RESPONSE TO REQUEST FOR ADDITIONAL INFORMATION

APR1400 Design Certification

Docket No. 52-046

RAI No.: 540-8729
SRP Section: 08.02 - Offsite Power System
Application Section: 8.2
Date of RAI Issue: 02/21/2017

Figure 1 – Typical OPC Detection and Protection Sequence Diagram (with non-Class 1E detection features)

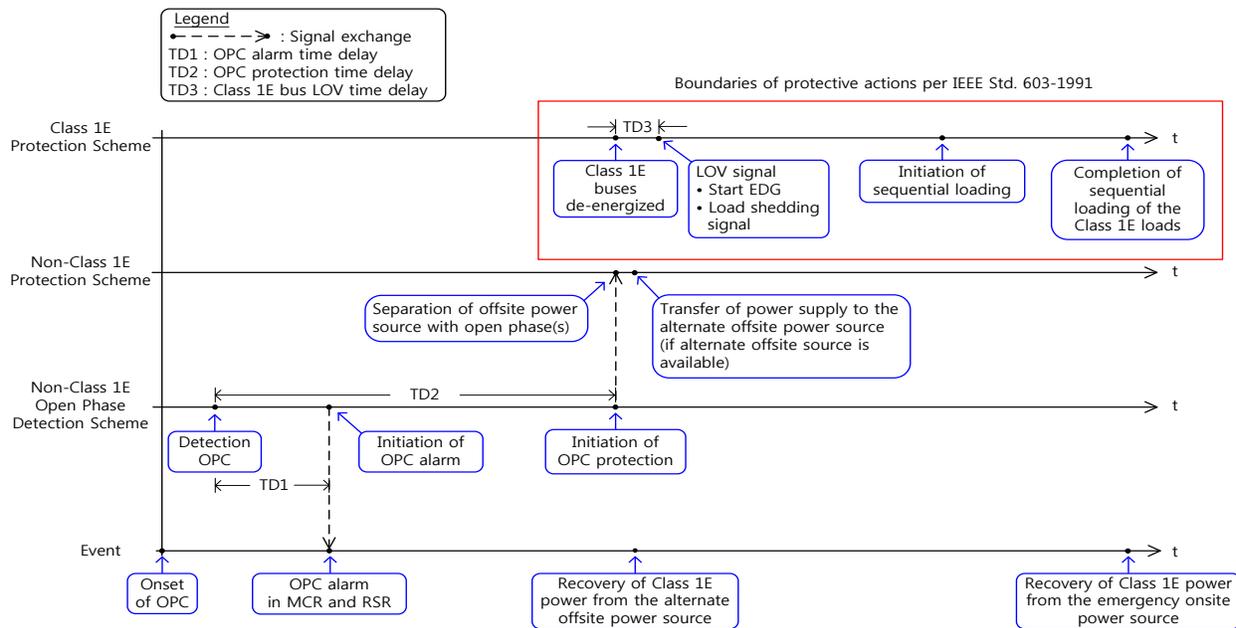
Item 1.c) Protection scheme should comply with applicable requirements including single failure criteria for ESF systems as specified in 10 CFR Part 50, Appendix A, GDC17, and 10 CFR 50.55a(h)(2) or 10 CFR 50.55a(h)(3), which require compliance with IEEE Std 279-1971 "Criteria for Protection Systems for Nuclear Power Generating Stations" or IEEE Std 603-1991, "Standard Criteria for Safety Systems for Nuclear Power Generating Stations." RG 1.153, "Criteria for Power, Instrumentation, and Control Portions of Safety Systems," provides additional guidance on this topic.

If protective features are provided in a non-Class 1E system only, a failure of the non-Class 1E scheme should not preclude the onsite electrical power system from performing its safety function given a single failure in the onsite power system.

As depicted in Figure 1, the APR1400 overall design features to address an OPC will encompass non-Class 1E and Class 1E systems. Considering the application of IEEE Std. 603-1991, only the Class 1E portion of the design features is subject to the applicable requirements, including the single failure criteria for ESF (Class 1E) systems. Compliance with the requirements for the Class 1E system is addressed in DCD Tier 2, Subsections 8.3.1.1.2 and 8.3.1.2.2. If the COL applicant chooses an OPDP system bounded only for the Class 1E system, the OPDP system as a whole should comply with applicable requirements, including single failure criteria for ESF (Class 1E) systems.

If a failure occurs in the non-Class 1E part of OPC detection and protection features (including a failure of redundant detection features), the failure does not preclude the onsite electric power system from performing its safety function given a single failure in the onsite power system based on the following.

- The worst case single failure in the non-Class 1E portion of the detection and protection features is spurious operation of the detection and protection feature. This condition causes unwanted separation of the offsite power source formerly supplying safety loads. As a result, the Class 1E buses will lose electric power unless the offsite power is transferred to the alternate offsite source. And the loss of voltage condition will automatically initiate operation of the emergency power source for safety loads and maintain the ability of supplying electric power to ESF loads.

- There is no physical or functional interface or interdependency between a failure in the non-Class 1E features and protective actions of the Class 1E features. No single point vulnerability exists between the non-Class 1E and Class 1E features owing to proper physical separation in accordance with IEEE Std. 384-1992 as endorsed by RGs 1.32 and 1.75.

- The Class 1E protection scheme is redundant and independent, so the safety function of the Class 1E system is not compromised given a single failure in the onsite power system.

- Therefore, a failure in the non-Class 1E portion of the OPC detection and protection features does not preclude the onsite electric power system from performing its safety function given a single failure in the onsite power system.
